CITY OF ALBUQUERQUE

RE: 3017 11th Street NE

Grading and Drainage Plan Engineer's Stamp Date: 10/29/24

Hydrology File: H13D122

64.8 64.8 -64.0-New Home FF = 65.564.3 65.0 64.5 **-**•64.8-64.0 65.2 -64.0job no: 65.0 drawn: **Author** checked: Checker New Home 65.1 Aug. 18, 2021 date: Garage FF = 65.5FF = 65.5 65.0 65.0 ⁻64.0 65.0 64.4 64.5 64.5 64.9 64.7 RESIDENCE 64.8 1 Drainage Plan
1" = 10'-0" ₹ 5 sheet no:

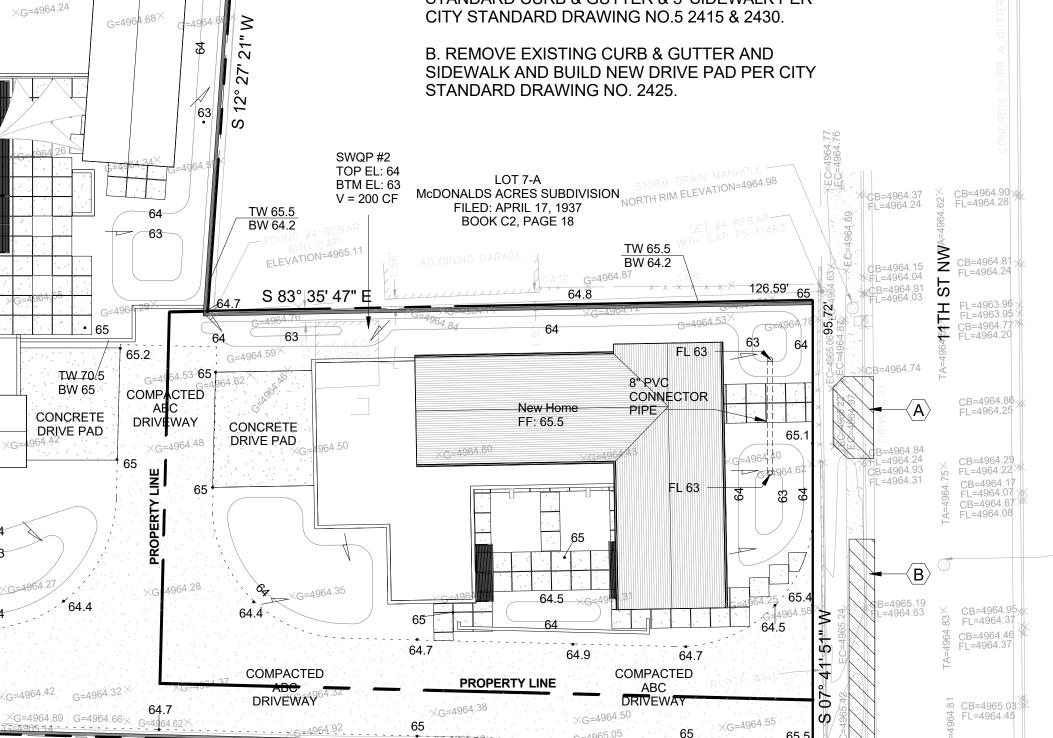
Based upon the information provided in your submittal received 11/06/2024, the Grading & Drainage Plan is <u>approved</u> for action by the Development Facilitation Team (DFT) on Site Plan for Building Permit or for action by the Development Hearing Officer (DHO) on Preliminary Plat.

1. Please submit a more detailed Grading & Drainage Plan to Hydrology for review and approval. This digital (.pdf) is emailed to PLNDRS@cabq.gov along with the Drainage Transportation Information Sheet.
